# A d d e n d u m

Iowa Department of Transportation  
Office of Contracts                      Date

Date of Letting: February 17, 2015  
of Addendum: January 22, 2015

<b>B.O.</b>	<b>Proposal ID</b>	<b>Proposal Work Type</b>	<b>County</b>	<b>Project Number</b>	<b>Addendum</b>
118	98-C098-068	PCC OVERLAY - UNBONDED	WORTH	STP-S-C098(68)--5E-98 FM-C098(67)--55-98	17FEB118.A01

SHEET C.02, TABULATION WORTH 04

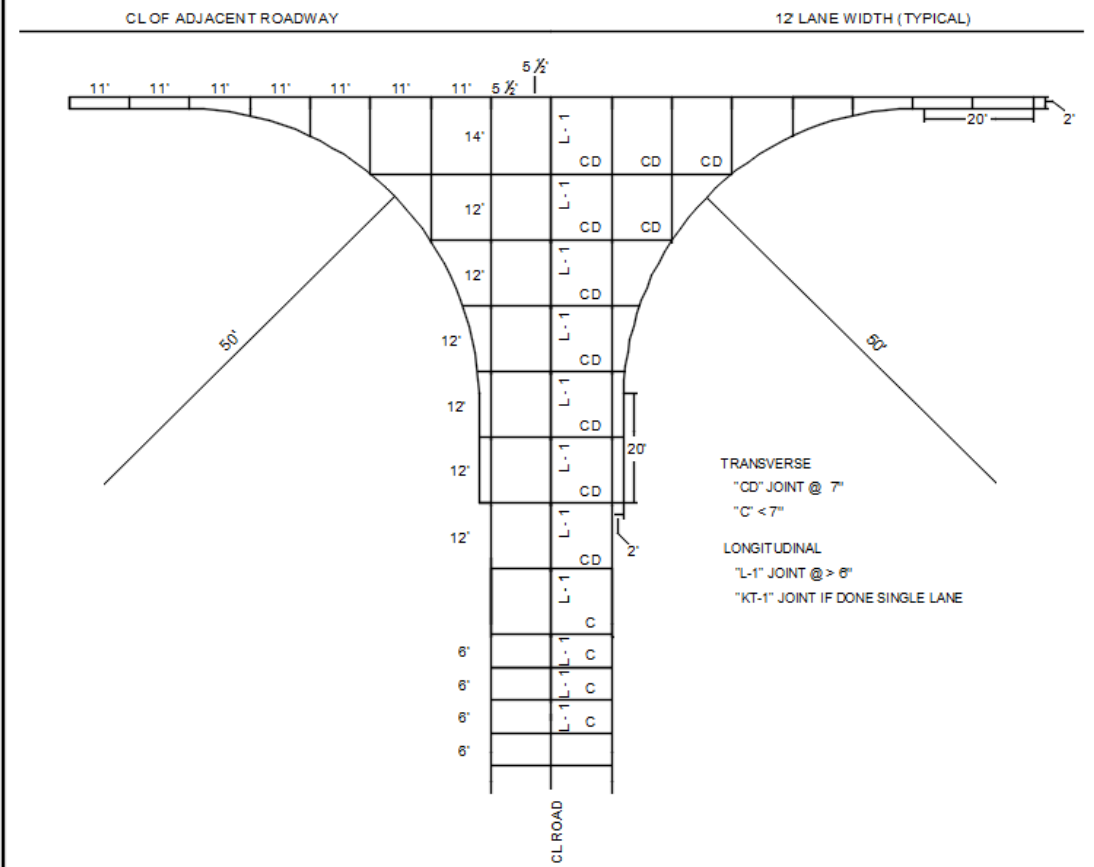
Change the first entry in the first column from 24+62 to 24+42

Change the fourth entry in the third column from 32+97 to 33+17

Change the first and fourth entries in the sixth column from 440 to 488.89

Change the ninth entry in the sixth column from 173.56 to 433.25

Change the Total from 3609.16 to 3447.25.
